Date: June 5<sup>th</sup>, 2024

Project Description: Reese Townhomes

**Project/File:** **Reese Townhomes / GC24-0011 / SUBFY2024-0003**

This is a preliminary plat application to be processed as a planned unit development, to allow for the development of a 32-lot subdivision consisting of 28 residential lots and 4 common lots on 1.4 acres.

# Site Plan

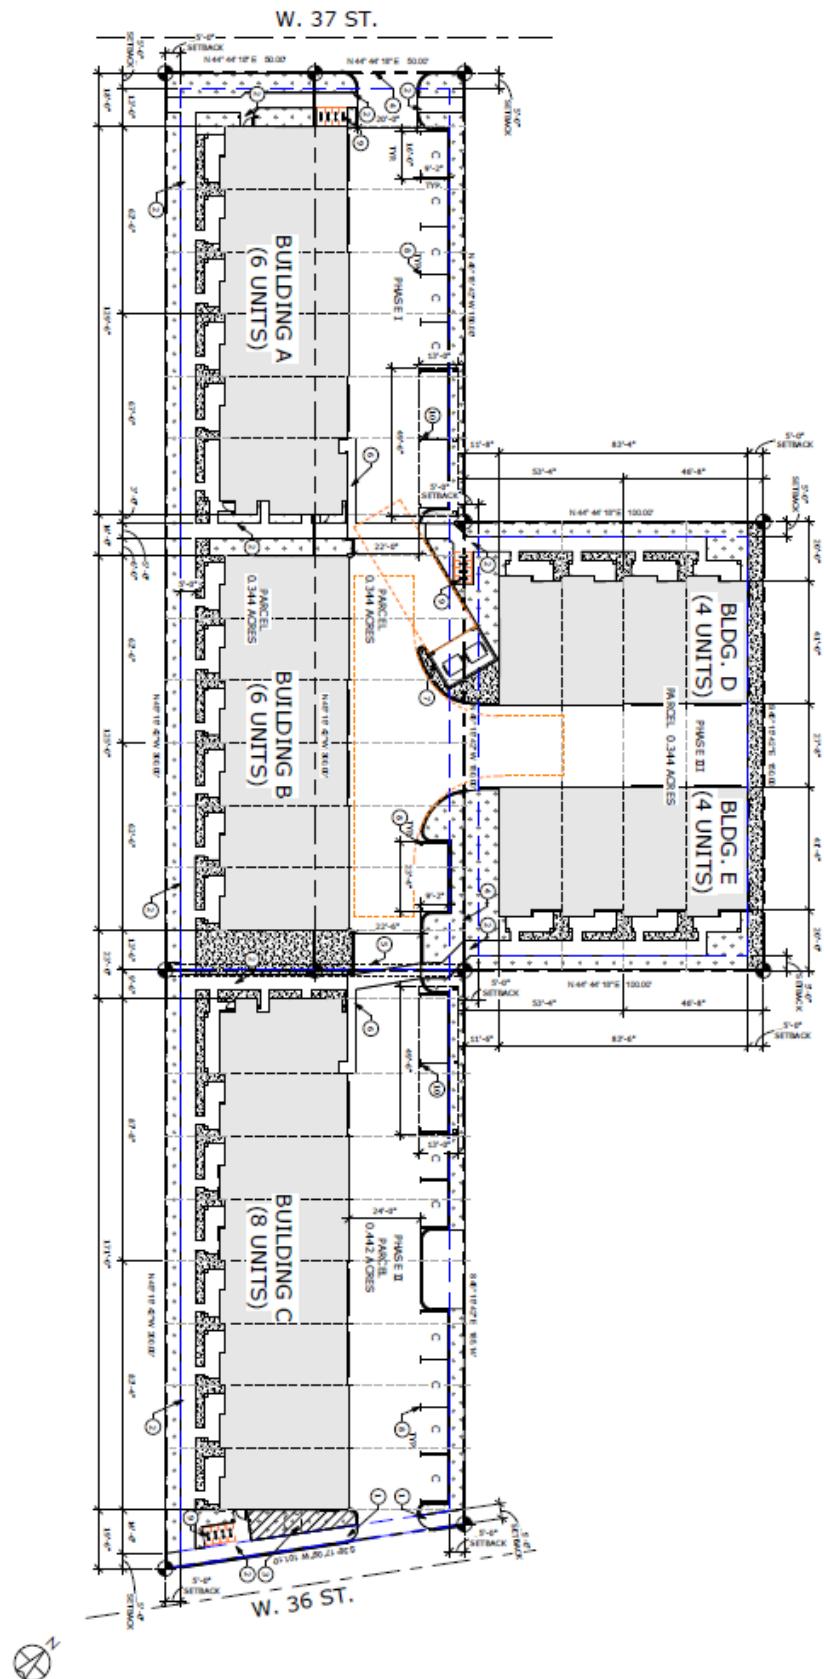
1. Repair or replace any damaged or deficient transportation facilities on 36<sup>th</sup> Street abutting the site, as determined by ACHD staff, and consistent with the current version of PROWAG.

2. Construct 37th Street as  $\frac{1}{2}$  of a 36-foot wide commercial street section to include pavement widening, curb, gutter, an 8-foot wide landscape strip and 5-foot wide detached concrete sidewalk abutting the site.

3. Dedicate additional right-of-way to 2-feet behind back of sidewalk or for detached sidewalk, reduce the right-of-way width to 2-feet behind back of curb and provide a permanent right-of-way easement from the right-of-way line to 2-feet behind back of sidewalk. Sidewalk should be located wholly within right-of-way or wholly within an easement.

4. Reconstruct and widen the existing driveway onto 36<sup>th</sup> Street, located 332-feet south of Stockton Street, as a 20-foot wide curb return type driveway as proposed.

5. Construct a 20-foot wide curb return type driveway onto 37<sup>th</sup> Street, located 329-feet south of Stockton Street.
6. Submit civil plans to ACHD Development Services for review and approval. The impact fee assessment will not be released until the civil plans are approved by ACHD.
